1 SITE PLAN FOR ADMIN. AMENDMENT
1" = 20'

HANOVER STUDIOS
6500 HANOVER RD NW
ALBUQUERQUE, NM 87121

SHEET TITLE
SITE PLAN FOR ADMINISTRATIVE AMENDMENT

SHEET NO.
A-101

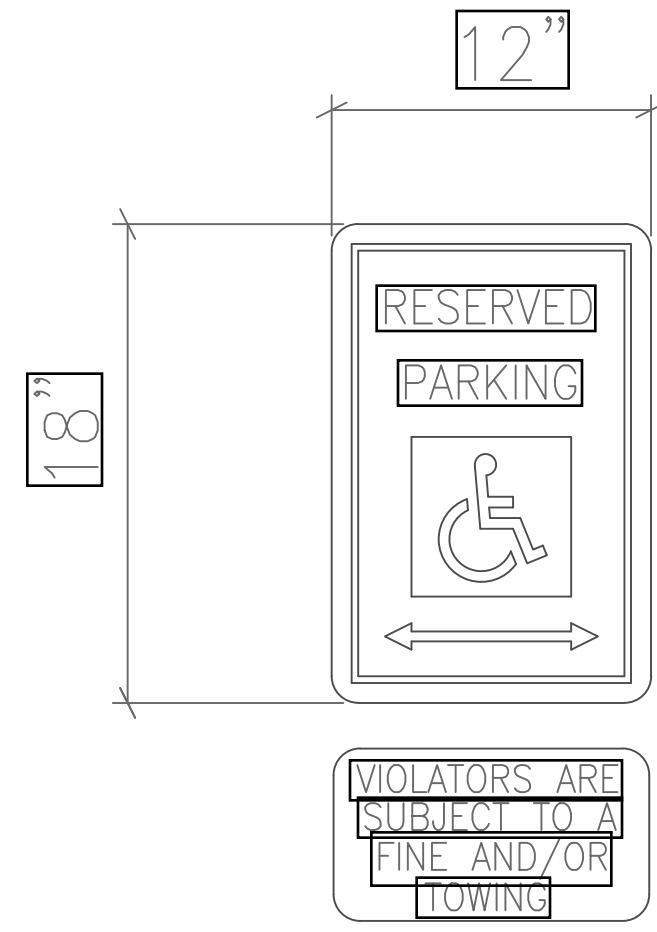
- 1. NEW 6'-0" HIGH PRIVACY WALL WITH COLORED BLOCK.
- 2. NEW VEHICLE ACCESS GATE.
- 3. NEW PEDESTRIAN GATE.
- 4. NEW STOP SIGN PER COA STANDARD XX
- 5. REMOVAL OF EXISTING MEDIAN.
- 6. NEW LANDSCAPED AREA.
- 7. NEW PARKING SPACES.
